TECHNICAL BULLETIN
K250NAS1
15 OCT 2014

Service Action: Undertray Rework To Remove Steering Gear Gaiter Foul

XJ Range (X351)
Model Year: 2015
VIN: V75431-V76851

E171091

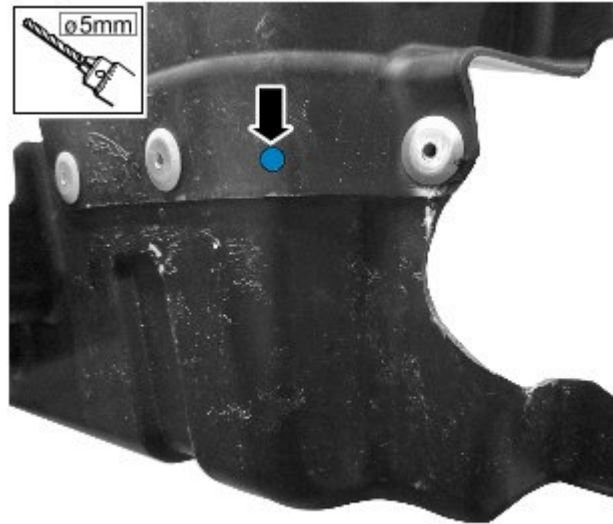
5. Drill the new rivet location in the undertray assembly.

E171094

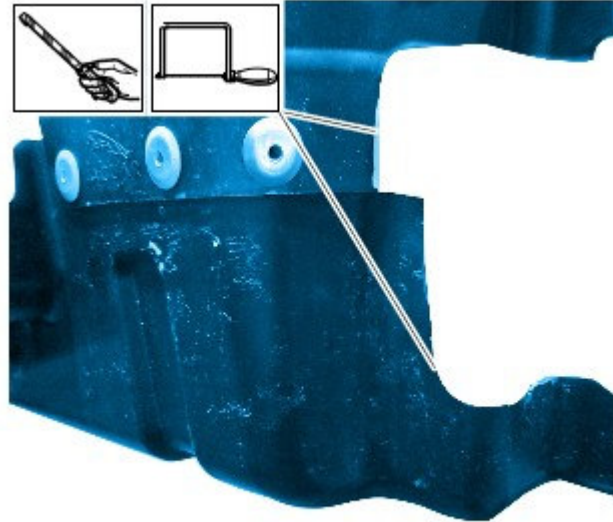
9. Using a suitable tool, remove any sharp edges from the undertray assembly.

E171101

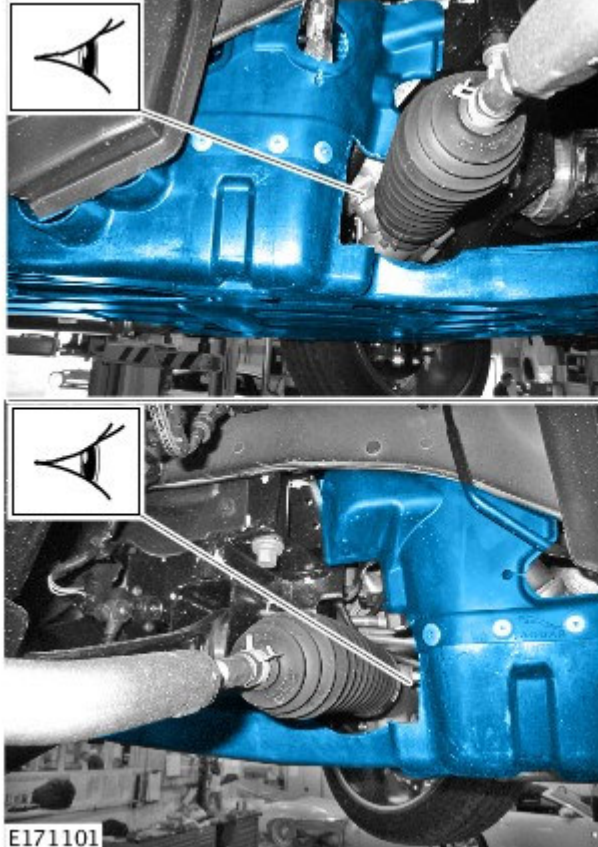
18.  **NOTE: Both left-hand-side and right-hand-side must be checked.**

Check that there is a minimum 18mm clearance between the steering gear gaiter and undershield.
